Installation Instructions: New A5 Film Pocket BOARD
Part Number: 9402791P

The **new** A5 Board:

A5 Board

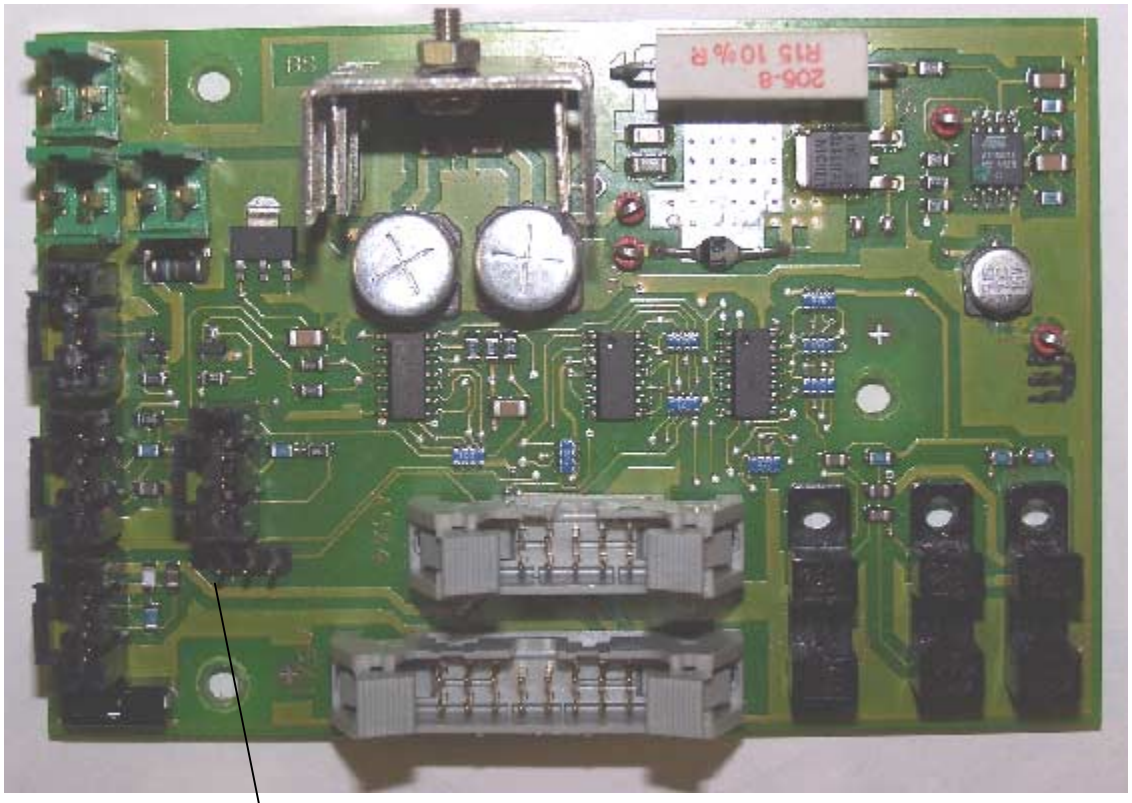
- Replaces the **old** A5 Boards, part numbers 9228590 and 9229590, because of parts that have become obsolete.
- Provides an additional connector (A5X9) for the Precise Position Sensor that is used in the *Kodak X-Omat* MULTILOADER 7000.
- Is fully compatible with the following equipment:
  Kodak X-Omat MULTILOADER 300
  Kodak X-Omat MULTILOADER 300 PLUS
  Kodak X-Omat MULTILOADER 7000
  Kodak MINILOADER 2000
  Kodak MINILOADER 2000P

1. De-energize the equipment.
2. Remove BACK PANEL.
3. Open the FILM CHUTE.
4. Disconnect the CABLES AND CONNECTORS from existing A5 BOARD.
5. Remove the old A5 BOARD, save all hardware.
6. On the NEW A5 BOARD set JUMPER on *A5X13* as follows:

Equipment	*A5X13* Jumper
Kodak X-Omat MULTILOADER 7000	Pins 1-2
Kodak X-Omat MULTILOADER 300 and 300 PLUS	Pins 2-3
Kodak MINILOADER 2000 and 2000P	Not Used

7. Install the NEW A5 BOARD using hardware from step 5.
8. Connect the CABLES AND CONNECTORS from step 4, to new A5 BOARD.
9. Close FILM CHUTE.
10. Install BACK PANEL.
11. Check for correct operation.

FILM POCKET BOARD A5 LAYOUT

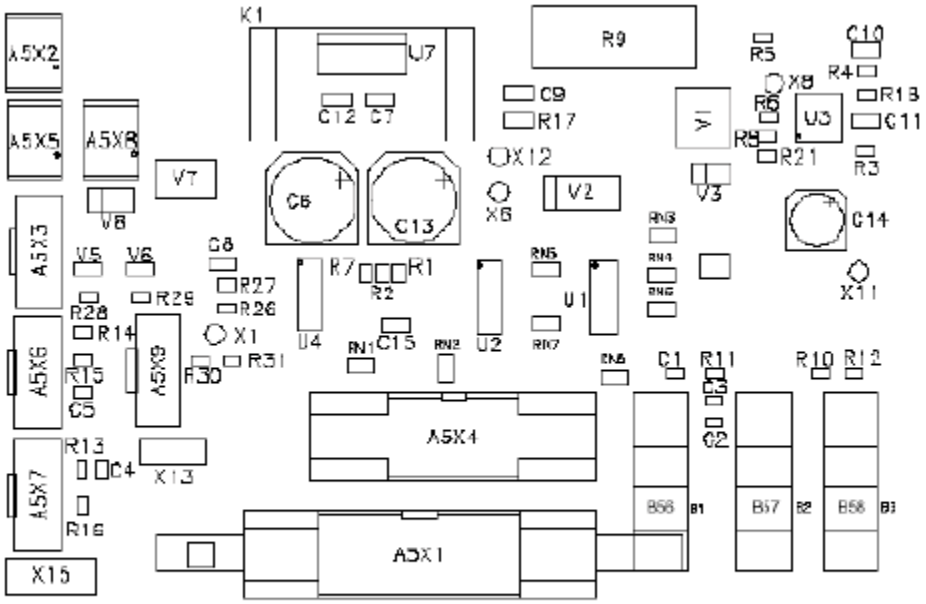
X1 B59, Double Sheet Detector, Setup test point
X6 VPE50 (+30Vdc) Unreg.
X8 VPE12 (+5Vdc) Reg.
X11 GNDPE
X12 VPE52 (+24Vdc) Reg.
X15 GNDPE
